Access Compliance Report

Public Rights-of-Way

(Curb Ramps)

Intersection ID: 10033070	Main Street: NORTH_COMMUNITY_HOUSE_RD	Cross Street: N/A	Location: SW
ADA ID: E1CAF7444EDB	Ramp Type: Perp	Initial Pass/Fail: Fail	Overall Compliance: No
Codes/Mitigation Info/Possible Solution		Field Measurements/Component Compliance	
Severity Score: 12.5

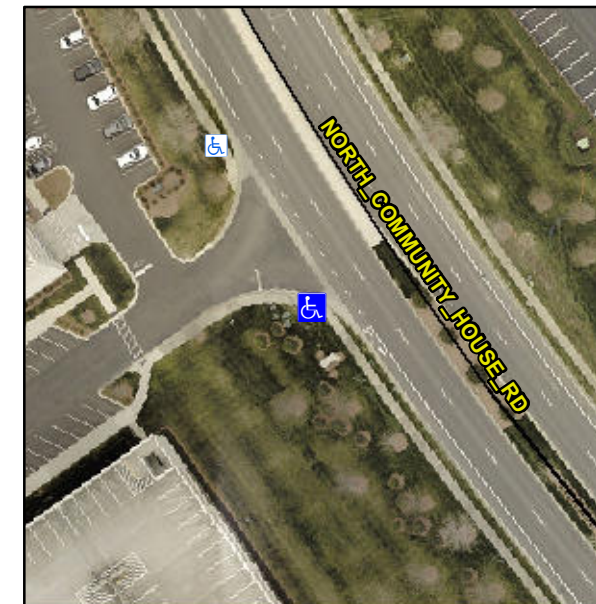
Not Found, R304.2.2

Compliance	Description	Data	Compliance	Description	Data
N/A	Ramp Length (in)	59.5	No	Ramp Slope (%)	11.3
Yes	Ramp Width (in)	58.0	Yes	Ramp XSlope (%)	1.2
N/A	Flare Type LT	N/A	N/A	Flare Type RT	N/A
N/A	Flare Slope LT (%)	N/A	N/A	Flare Slope RT (%)	N/A
N/A	Flare Traversable LT?	N/A	N/A	Flare Traversable RT?	N/A
N/A	Landing Length (in)	N/A	N/A	DWS Provided?	N/A
N/A	Landing Width (in)	N/A	N/A	DWS Contrast?	N/A
N/A	Landing Slope (%)	N/A	N/A	DWS Length (in)	N/A
N/A	Landing X Slope (%)	N/A	N/A	DWS Full Width?	N/A
N/A	Landing Curb? (Y/N)	N/A	N/A	DWS Offset (in)	N/A
N/A	Shared Landing?	N/A			
N/A	Gutter Ponding?	N/A	N/A	Gutter Slope (%)	N/A
N/A	Gutter Lip Ht (in)	N/A	N/A	Gutter X Slope (%)	N/A
N/A	Painted X Walk1?	No	N/A	Painted X Walk2?	N/A
	X Walk 1 Direction	To NW		X Walk 2 Direction	N/A
N/A	X Walk 1 Width (in)	N/A	N/A	X Walk 2 Width (in)	N/A
	X Walk 1 Slope (%)	5.4		X Walk 2 Slope (%)	N/A
	X Walk 1 X Slope (%)	6.3		X Walk 2 X Slope (%)	N/A

Remove & Replace Entire Ramp.
